# **PRELIMINARY/FINAL DRAINAGE REPORT FOR HIGH PLAINS FILING NO. 1**

PCD FILE NO's: SP-18-003  
SF-18-024

PRELIMINARY/FINAL DRAINAGE REPORT  
HIGH PLAINS FILING NO. 1

Project: High Plains Filing no. 1  
Basin ID: Design Point 1

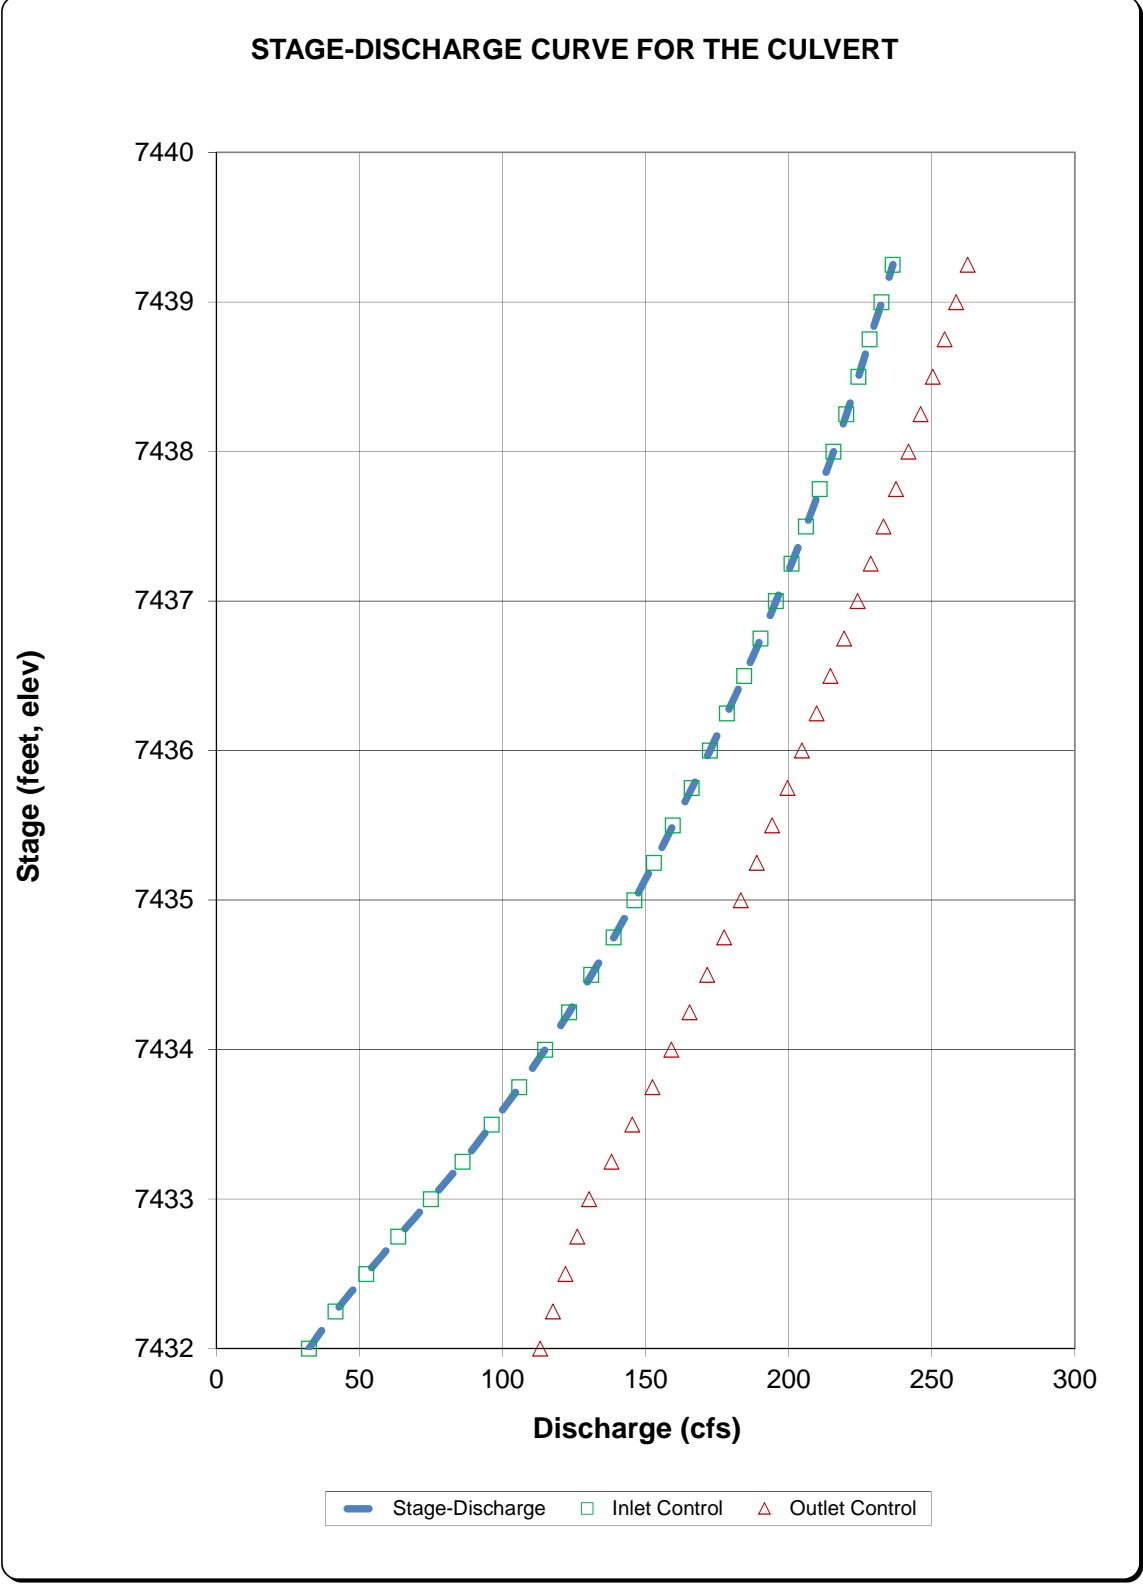
2. Submit the outlet protection calculation  
**Review 2:**  
 Unresolved.

3. Provide the Hw/D. Per DCM Hw/D must be less than 1.5.  
**Review 2:**  
 Unresolved.

1. Resolved.

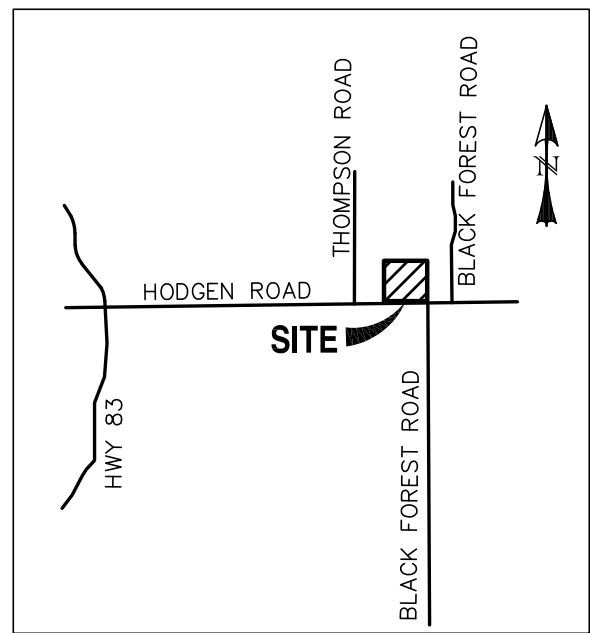
Provide a footnote explaining/showing how the set back was calculated.
